**Updated Response to Request for Additional Information  
Specific to the Electric Power Research Institute Report 1025203,  
"Utilization of the EPRI Depletion Benchmarks for Burnup Credit Validation"**

**Figure 1-1: Energy Spectrum Index (EALF) of the Benchmarks and Typical Racks as a Function of Burnup**

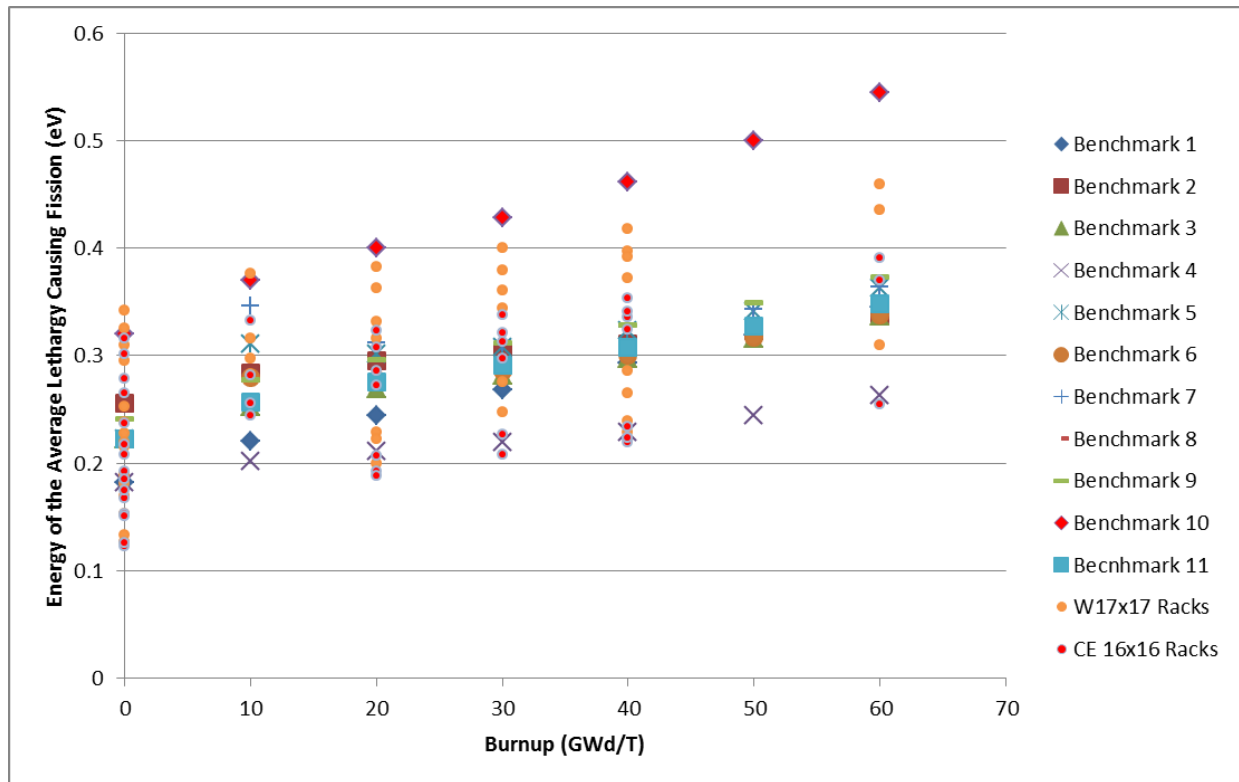
1. In Section 2, it is stated that, “In particular, it is important to assure that the neutron energy spectrum for the critical system is bounded by the neutron energy spectrum in benchmarks used for the determination of  $\Delta k_d$ .” With the large variation in possible Spent Fuel Pool (SFP) configurations, how is it ensured that the neutron energy spectrum in benchmarks used for the determination of  $\Delta k_d$  are similar (or bound) the neutron energy spectrum for all possible critical systems?

The term “bounded by” in Section 2 should be replaced with “representative of” as it is not likely that all the possible spectrums in the SFP will be strictly bounded by the set of 11 benchmarks. However, the particular benchmarks included were selected to provide a range of spectra that are representative of the spent fuel pool environment. Figure 1.1 demonstrates this pictorially, where the Energy of the Average Lethargy causing Fission (EALF) for the benchmarks is compared to the EALF from a range of typical SFP racks as a function of burnup. It is observed that the hardest spectrum is from Benchmark 10, which contains 1500 ppm soluble boron as it has the highest EALF of all benchmark cases at all burnups. The softest spectrum is from Benchmark 4, which uses the OFA fuel pin design as it has the lowest EALF of all benchmark cases at all burnups. The same rack and fuel configurations, 56 cases in total, used in the previous EPRI sensitivity studies [2] are used for the analysis. The key parameters for rack descriptions are provided in the first few rows of Table GR-1. As evident from the points plotted in Figure 1.1, the benchmarks bound the majority of the spent fuel rack configurations and are representative of all configurations. The prime exception where the benchmarks do not necessarily “bound” the typical rack configurations is in the fresh fuel cases (zero burnup), where the spectrum is much softer than what the benchmark cases represent. However, the benchmarks were chosen with the intent to represent the spectrum associated with spent fuel for quantification of the depletion uncertainty and the fresh fuel configuration is already covered by the fresh fuel benchmarks that are addressed in NEI 12-16 [6].

**Figure 3-1 HZP to HFP Bias as a Function of Burnup**

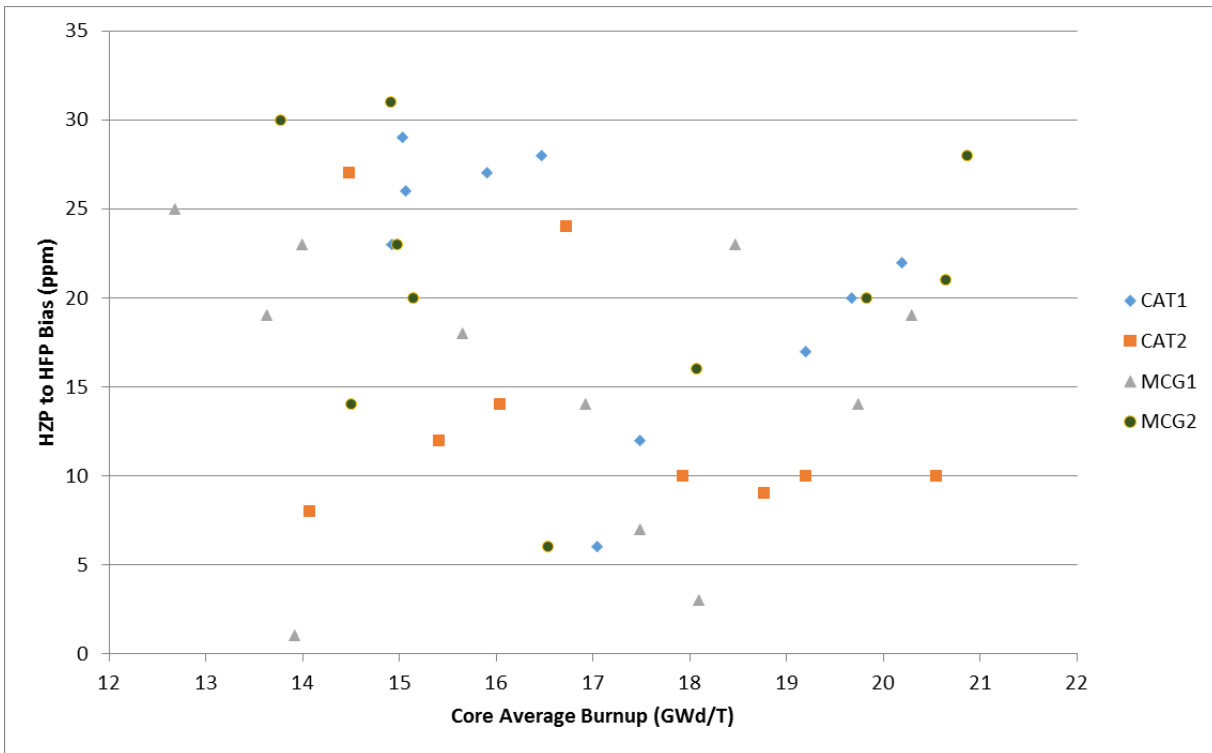
3. EPRI Report 1025203 bases the 11 benchmark criticality case bias and uncertainty estimates, intended to cover reactivity calculations in SFP conditions, on bias and uncertainty estimates inferred from HFP operating reactor measurements. Application of bias and uncertainty in this manner requires bias and uncertainty extrapolation in time (decay), fuel temperature, moderator temperature, etc. Provide additional discussion on the basis for the bias and uncertainty, and justification for the limitations and assumptions associated with the following conditions:
  - a. an extension of operating reactivity measurements to 100 hours (Were restart critical configurations considered?),

The uncertainty in going from HFP to cold rack conditions at 100 hours is conservatively assessed as 452 pcm (Table 8-10 of the Benchmark report) as presented in Section 8.5 and 8.6 of the Benchmark report [1]. This assessment was made assuming the uncertainty is dominated by the uncertainty in the cross section library and TSUNAMI was used to propagate the cross section uncertainty.

Although agreement with HZP startup data was not used directly in the assessment of the bias and uncertainty in going from HFP to cold conditions at 100 hours, the performance of CASMO-4/SIMULATE-3 in predicting reactor conditions are shown in Section 5.4 of the Benchmark report. Tables 5-3 through 5-6 of the Benchmark report show the agreement between measured and predicted BOC HZP and HFP critical soluble boron concentrations and the agreement between measured and predicted EOC HFP critical soluble boron concentrations. The difference between the third from the last column and the second from the last column is a HZP to HFP bias in the CASMO-4/SIMULATE-3 system. Figure 3.1 below plots this bias as a function of the BOC core average burnup. There is a HFP to HZP bias of about 17 ppm. It is assumed that this bias is not burnup dependent. Using the general rule of thumb equating 1 ppm to 9 pcm, 17 ppm results in about 150 pcm effect in reactivity. This ~150 pcm is well within the claimed total hot to cold uncertainty of 453 pcm.

The restart critical configurations were not considered in the determination of the bias and uncertainty.
